APPLICATION NO.	FILING DATE	FIRST NAMED INVENTOR	ATTORNEY DOCKET NO.	CONFIRMATION NO.
10/580,370	09/29/2006	Pierre Malek	0617-1023	2077
466 7590 03/18/2011 YOUNG & THOMPSON 209 Madison Street			EXAMINER	
			ORTIZ, RAFAEL	
Suite 500 Alexandria, VA 22314			ART UNIT	PAPER NUMBER
, , , , , ,			3728	
			NOTIFICATION DATE	DELIVERY MODE
			03/18/2011	ELECTRONIC

## Application No. Applicant(s) 10/580.370 MALEK, PIERRE Office Action Summary Examiner Art Unit RAFAEL ORTIZ -- The MAILING DATE of this communication appears on the cover sheet with the correspondence address --Period for Reply A SHORTENED STATUTORY PERIOD FOR REPLY IS SET TO EXPIRE 3 MONTH(S) OR THIRTY (30) DAYS. WHICHEVER IS LONGER, FROM THE MAILING DATE OF THIS COMMUNICATION. Extensions of time may be available under the provisions of 37 CFR 1.136(a). In no event, however, may a reply be timely filed after SIX (6) MONTHS from the mailing date of this communication. - If NO period for reply is specified above, the maximum statutory period will apply and will expire SIX (6) MONTHS from the mailing date of this communication Failure to reply within the set or extended period for reply will, by statute, cause the application to b

Fig. 1

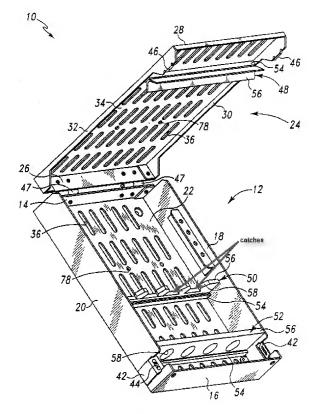
Claim 11

Spencer further discloses the lid (12) having two catches extending perpendicular to the lid in order to be in contact with a tool (see figure above).
